LOCATION Barrack St. Dock Facility
Wolfe Island Ferry Terminal

WOLFE ISLAND FERRY TERMINAL BUILDING
Barrack St., Kingston Ont.

RE: Wolfe Island Ferry Terminal Building
Barrack Street Dock at Ontario Street
Contract 89-404, (W.P. 222-86-00)
Hwy. #2, District 8, Kingston

RE: W.P. 222-86-00, Barrack Street Dock Facility
Wolfe Island Ferry Terminal Building
City of Kingston, District 8, Kingston

FOUNDATION PLAN	
Drawn By P.C.M.	Checked By S.T.R.
Scale 1:50	Date 12 JULY 1989
MTO Project No WP 222-86-00

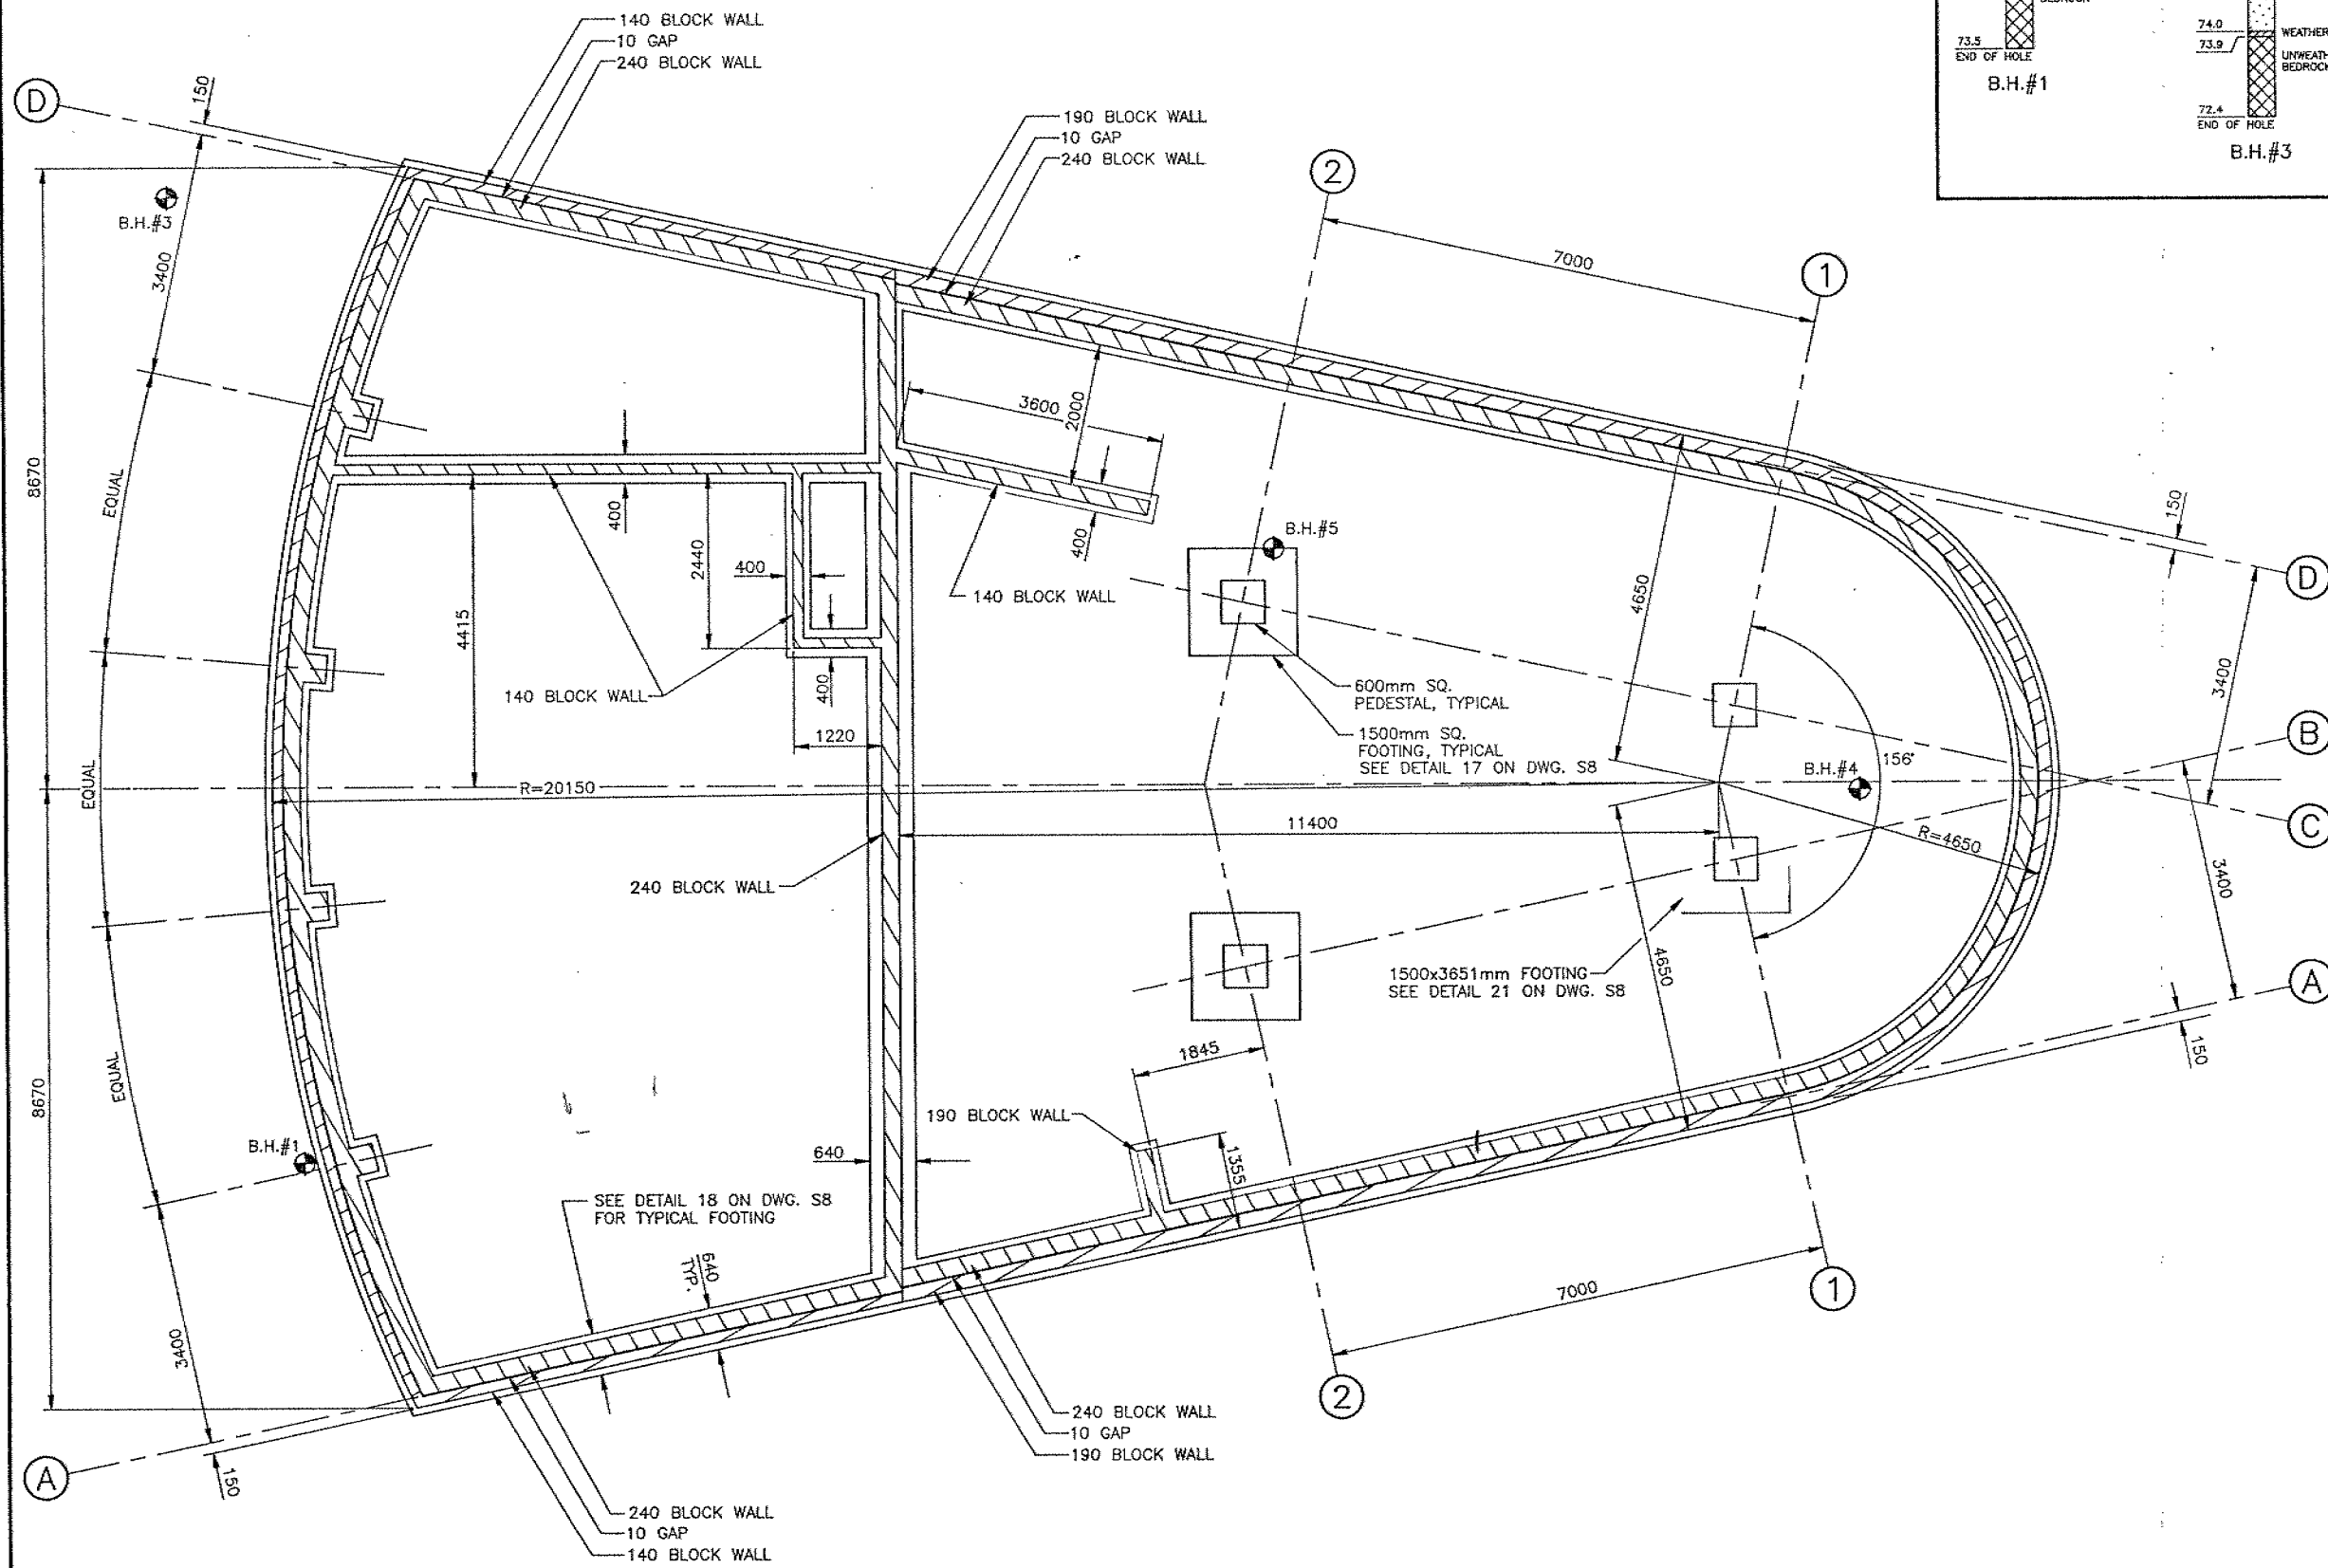
Our recommendation is changed so that footings may be founded on Granular 'A' pads that extend 1 m beyond the plan limits of the footings. That is, the requirement for 1:1 side slopes on the pad is withdrawn. It is understood that the McNeely design assumes bearing capacities not exceeding 200 kPa and that Sheet S-1 of the contract package will be changed to eliminate the inconsistency with the 346 kPa noted. Also the contract drawings should be changed to clarify that the Granular 'A' pad should be founded on bedrock.

- McNeely states that this requirement would result in excavation of most of site and that costs would be increased by \$20 k. This was checked and although most of the site would be dug up, this estimate of cost increase would be closer to \$10 k.
- McNeely states that the 1:1 requirement is something added by us at the review stage. This is true because it was not clearly stated in the original foundation recommendations. I checked with Pam Marbo who wrote the original report and she had intended for 1:1 slopes to be incorporated.
- McNeely states that their loading assumption was 200 kPa. This is inconsistent with the notes in the contract package Vol 5-1 which indicate a load of 346 kPa.
- The contract drawings do not indicate the subexcavation geometry and I am concerned that vertical excavations will not be feasible. I have concern that overburden should be excavated

In conclusion, after discussion with Pamela Marks who wrote original report, an recommendation is that the granular pad need only extend 1 m from plan limits of footings. However the contract drawings should be changed to reflect the 200 kPa assumption of McNealy instead of the 346 kPa statement on drawing S-1 and the details of subexcavation should be clarified to ensure granular pad is on bedrock and not mixed with material sloughed from sides or bottom of excavation.

FURTHER TO OUR TELEPHONE CONVERSATION OF AUG. 9/89, WE HAVE REVIEWED THE CONTRACT DRAWINGS AND DOCUMENTS FOR THIS PROJECT. AS DISCUSSED, WE RECOMMEND THAT THE DETAILS FOR CONSTRUCTION OF THE FOOTINGS ON GRANULAR PADS SHOULD BE CLARIFIED ON DRAWING 5-1. THE GRANULAR 'A' PAD SHOULD BE FOUNDED IN BEDROCK AND COMPACTED IN ACCORDANCE TO INTB STANDARDS. IN PLAN IT SHOULD EXTEND 1 M BEYOND THE FOOTING AT THE FOOTING LEVEL. IN SECTION THE SIDE SLOPES SHOULD BE 1H:1V AS ILLUSTRATED BELOW.

- NOTES:**
- SEE DRAWING S5 FOR GENERAL NOTES
 - SEE DRAWING S5 FOR BLOCK WALL REINFORCING
 - FOOTINGS TO BE FOUNDED ON COMPACTED GRANULAR 'A' CAPABLE OF SUSTAINING A BEARING LOAD (ALLOWABLE) OF 346 KPa. FOOTING SHALL NOT BE CAST UNTIL THE FOUNDING MATERIALS HAVE BEEN INSPECTED AND APPROVED BY THE ENGINEER.
 - ALL FOOTING CONCRETE TO HAVE A MINIMUM COMPRESSIVE STRENGTH AT 28 DAYS OF 20 MPa. THE SUPPLY, PLACEMENT AND CURING OF CONCRETE SHALL BE IN ACCORDANCE WITH CAN3-A23.1-M77 AND CAN3-A23.2-M77.
